# ITB # 26-408 Hampstead Library Construction Services

## Addendum 3

December 15, 2025

## Pender County Library, Hampstead Branch

Landscape Plan

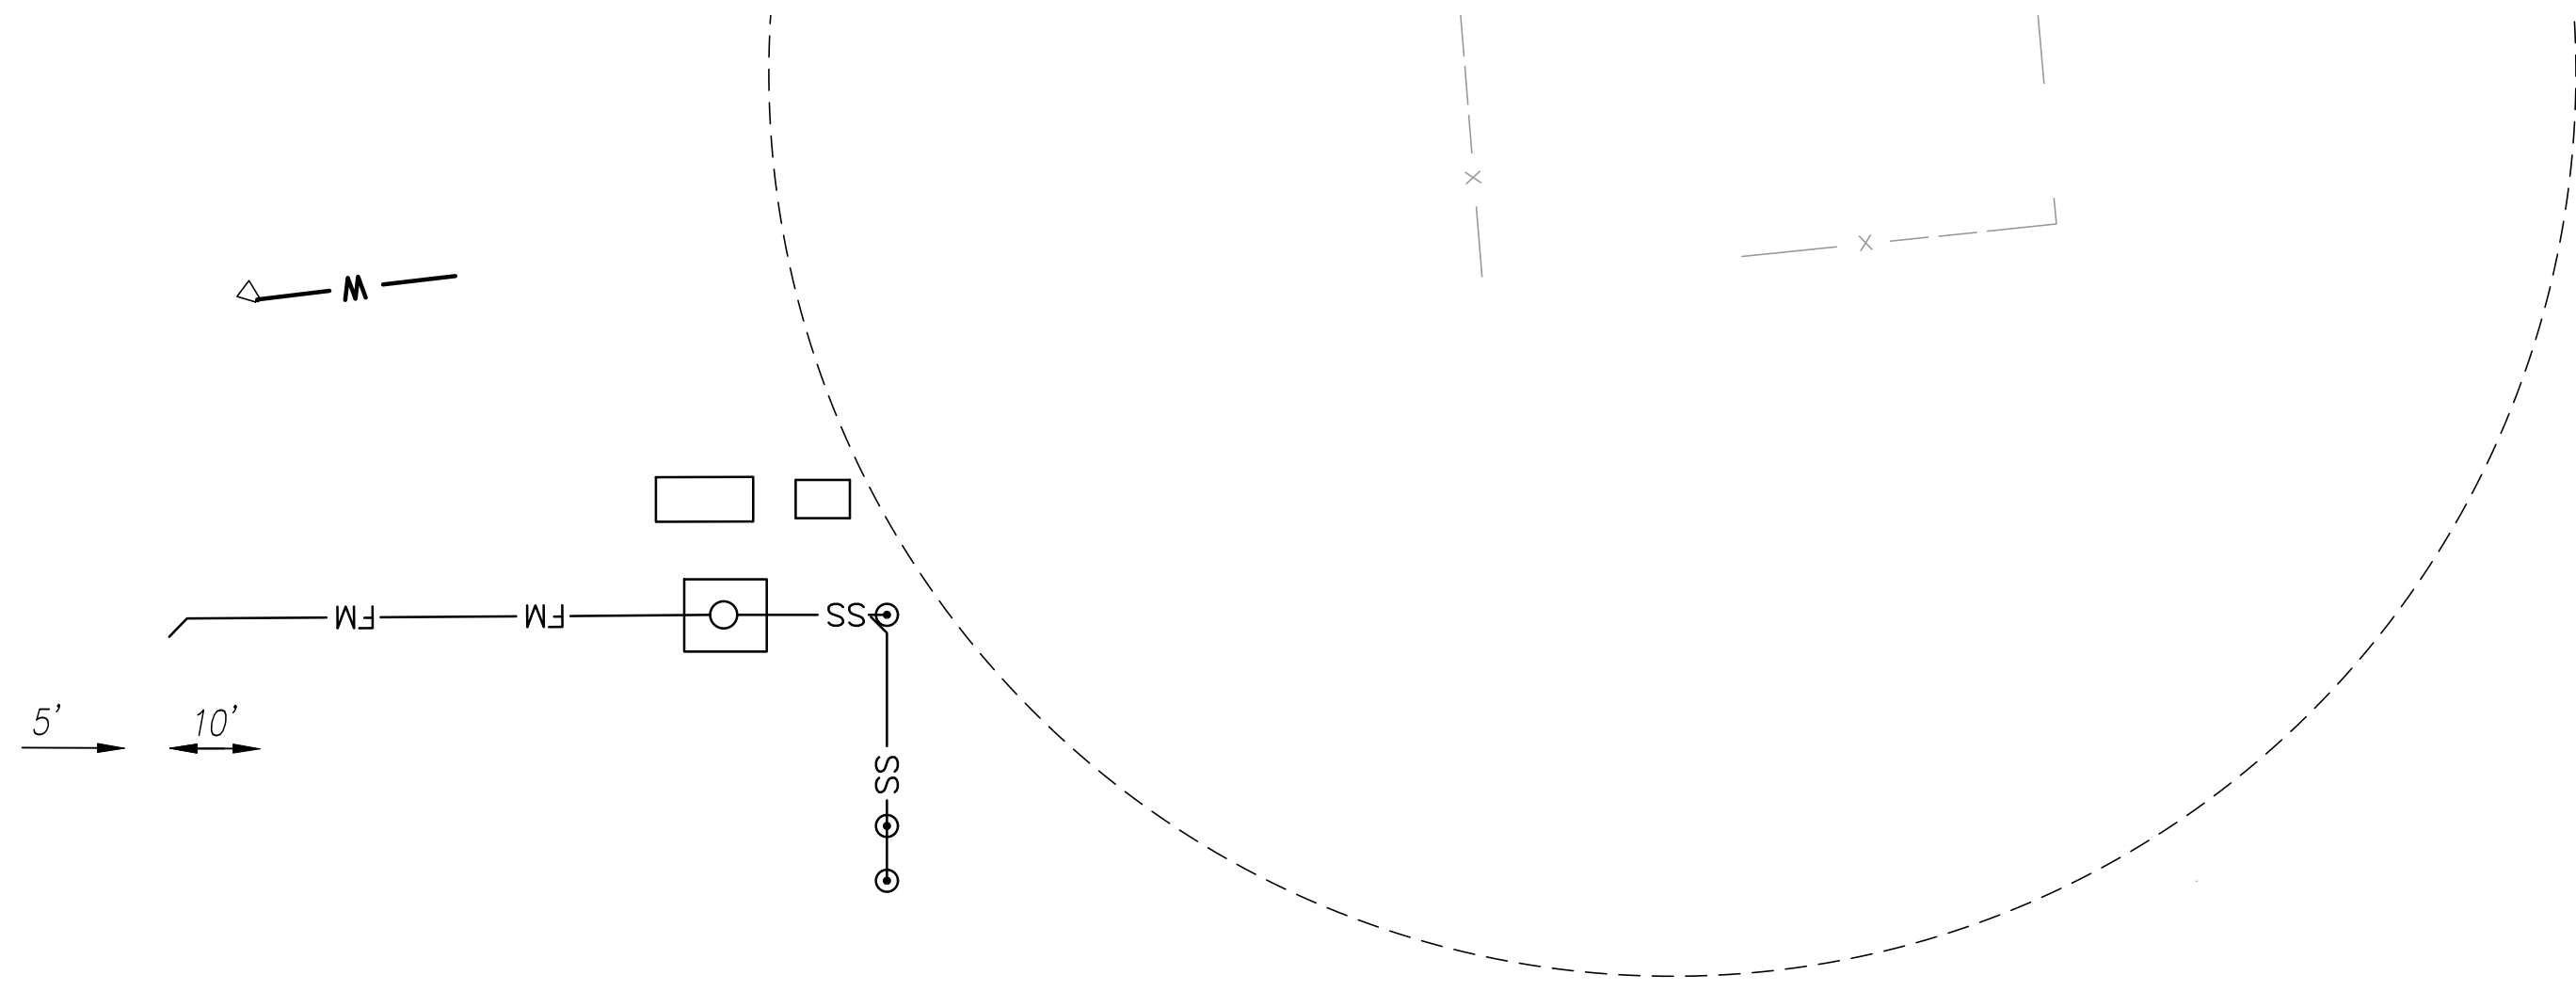
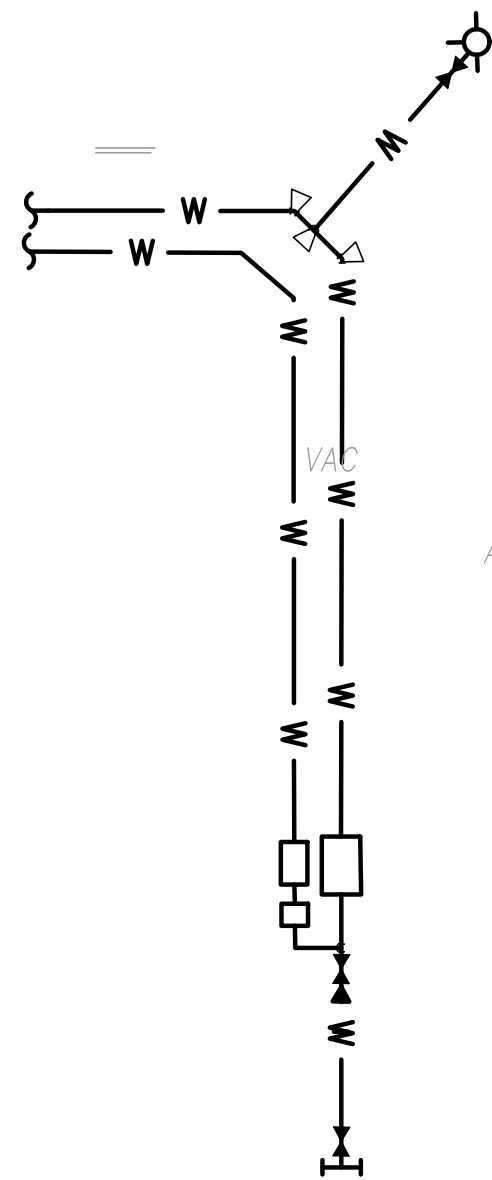
- 1. In the drawing index on sheets G1.0 and C0.0, please disregard reference to sheet C3.0. This sheet is not included in the drawing set and is not needed.
- 2. Sheet 5.0 Landscape Plan is replaced, see attached revised plan.
- 3. Sheet U5.1 Site Utility is replaced, see attached revised plan.
- 4. Sheet U9.5 Pluris Details 1 is replaced, see attached revised plan.
- 5. Sheet M3.0 Mechanical Control Diagrams, please add the following clarification:
  - a. Packaged Heat Pump Unit - Single Zone VAV & OA Economizer (PHP-1 & 6): Update sequence of operation A. Occupied 3. for Supply Air Fan **to adjust speed in stages to match compressor staging** to maintain space temperature setpoint.

Rev.	Date	Notes
1	12/9/25	TRC COMMENTS
